UNITED STATES PATENT AND TRADEMARK OFFICE

10/534,178

Office Action Summary	Application No. 10/534,178	Applicant(s) BECK, JOSEF	
	Examiner DNYANESH KASTURE	Art Unit 3746

DETAILED ACTION

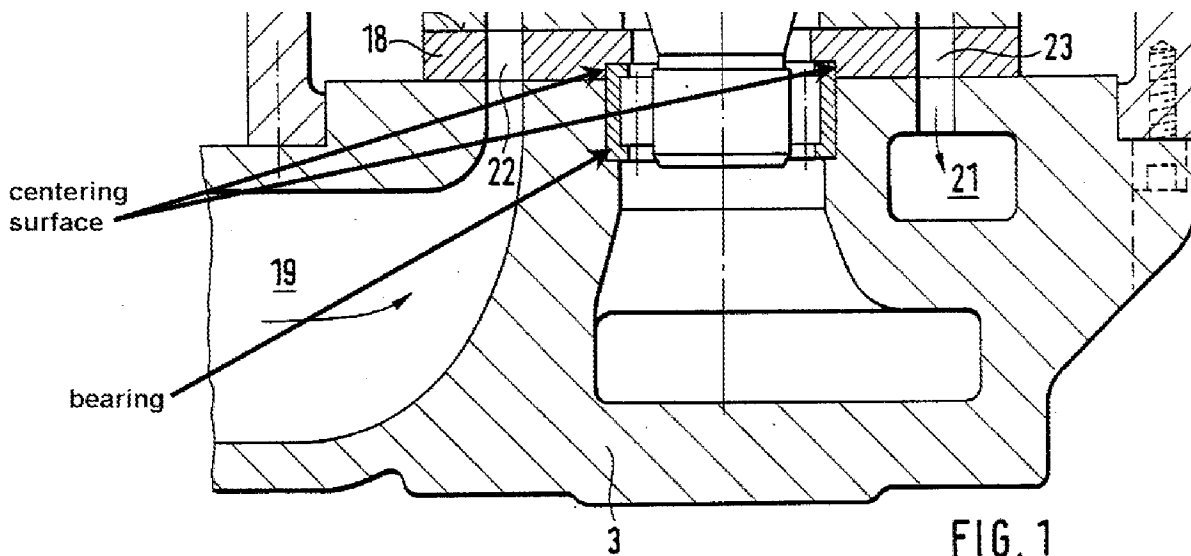
4. In Re claim 1, with reference to the excerpt of Figure 1 depicted above, Berthold et al discloses a control plate (18) for an axial piston machine (title) having at least two control openings (22, 23), by means of which cylinder bores (12) of a cylinder drum (9) rotatably mounted in a housing (2, 3) are alternately connected, on rotation of the cylinder drum, to a high-pressure connection (21) and a low-pressure connection (19), a through-opening (for shaft 8) being formed in the control plate, wherein a radially inner edge of the control plate is designed as a centering surface (annotated above) which centers the control plate on a centering body (bearing as annotated above) on the housing (3)

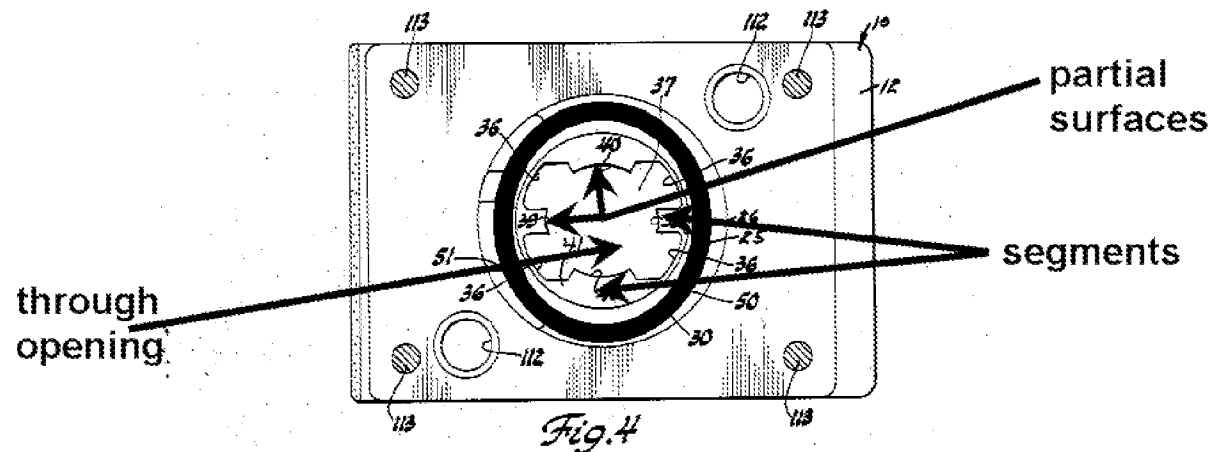
6. Nevertheless, with reference to Figure 4 annotated above, Neff discloses a plurality of partial surfaces (39, 40) formed on segments of the inner edge of shoulder (25), which extend radially inwardly as depicted into the through opening for "shaft" (39), the segments are separated by recesses (36). Note that the centering surface of Berthold et al and the partial surfaces formed on the segments of Neff are ALIGNMENT

7. It would have been obvious to a person having ordinary skill in the art at the time of the invention to modify the centering surface of Berthold et al so it comprises a plurality of segments with recesses as an alternate design choice that secures the bearing and port plate for the purpose of accommodating imperfections, if any, in the outer surface of the bearing because there are fewer contact surfaces.

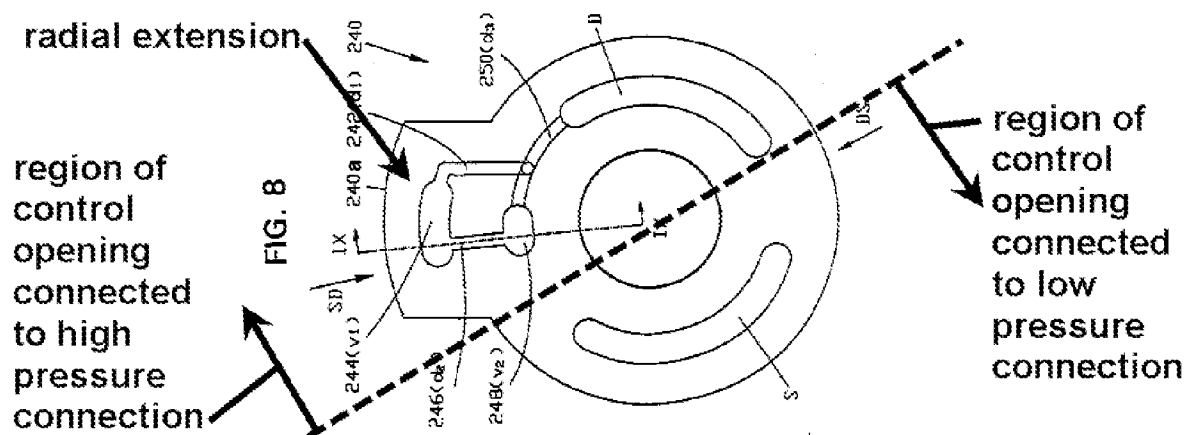
9. Nevertheless, with reference to Figure 8 depicted above, Perstnev et al discloses a control plate (30) with control opening (D) and a “bulging portion” (Column 3, Line 11) in a radial direction formed at an outer edge of the control plate only in the region of the at least one control opening plate (as evident from the annotations) that is connected to the high-pressure connection (associated with “D”).

bulging portion (radial extension) in the region of the control opening associated with the high-pressure connection as taught by Perstnev et al for the purpose of improving the achievement of noise reduction as stated in Column 1, Line 20 of Perstnev et al.

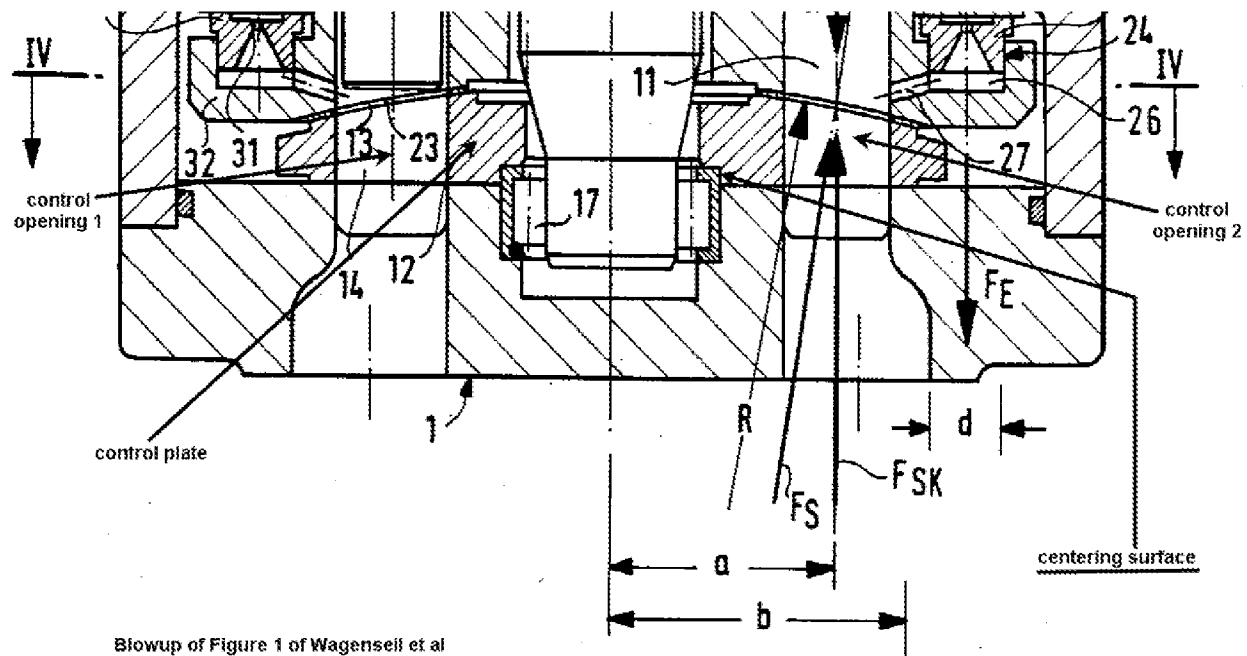
23. Nevertheless, Tovey depicts in Figure 1A that the interior of the control plate communicates with the space surrounding shaft (22) which further communicates with passageways (grooves) in the region on the side of the control plate facing away from the cylinder drum, the passageways further extending through elements (58) and (60) to passage leading back to the swash plate chamber (outside of the control plate) in the region of reference label "1r" and "68", thereby connecting the inner volume to the outer volume.

24. It would have been obvious to a person having ordinary skill in the art at the time of the invention to form a passageway/groove as taught by Tovey in the region of a separating area of the control plate of Berthold et al which connects the inner edge area of the control plate to the outer edge area for the purpose of balancing pressures.

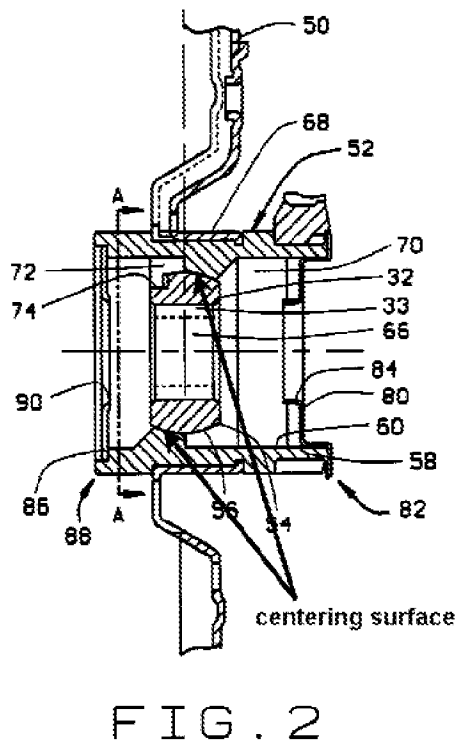
26. In Re claim 1, with reference to blowup of Figure 1, Wagenseil et al discloses a control plate (12) for an axial piston machine having at least two control openings (annotated), by means of which cylinder bores (11) of a cylinder drum (9) rotatably mounted in a housing are alternately connected, on rotation of the cylinder drum, to a high-pressure connection and a low-pressure connection, a through-opening (for shaft 4) being formed in the control plate (Column 4, Lines 25-30 state: "...control surface 13 of which has kidney-shaped control openings 14 which, as the cylinder 9 rotates, may or may not be covered by the piston bores 11 and therefore control, in the manner of valves, pump operation or motor operation of the axial piston machine 1"), wherein:

- the radially inner edge of the control plate is designed as a centering surface (annotated) which centers the control plate on a centering body (outer surface of bearing 17) on the housing.

28. Nevertheless, with reference to Figures 2 and 3 depicted above, Fisher et al discloses how housing element (52) is secured to the outer surface of bearing (32) by a plurality of partial surfaces (annotated) formed on segments (64) of the inner edge of the housing element (52), which extend radially inwardly into the through opening (33) and are separated by recesses (annotated) and a further recess (annotated) for receiving a rotation-locking element (72)

Fisher et al as an alternate design choice that secures the bearing and port plate, for the purpose of preventing the relative rotation between the port plate and the bearing.
